Provisional Acceptance Verification Report

La Vendimia PV Plant

Prepared for:
Matrix – TPG

Figure I.30. SCADA system in control room.

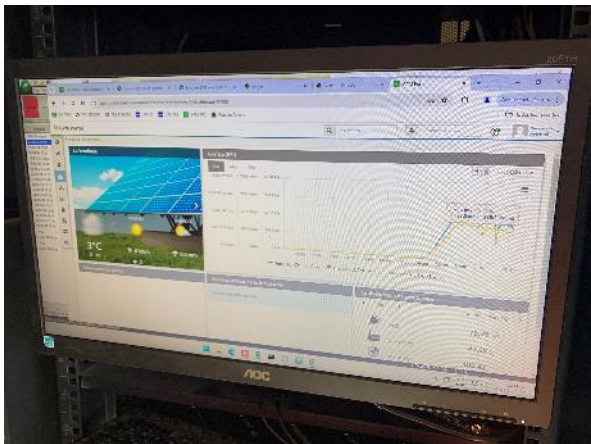
Control room and monitoring system
<p>Enertis inspected the control room. It includes: an air conditioning unit, access system, supervisory control and data acquisition (SCADA) cabinet, CCTV rack with a monitor and uninterrupted power supply (UPS) for security cameras. Some of these are shown in Figure I.29 and Figure I.30.</p> <p>The control room is in good condition, anchored to the foundations by bolts and grounded.</p>	
<p>Comment: Enertis raises no issues.</p>
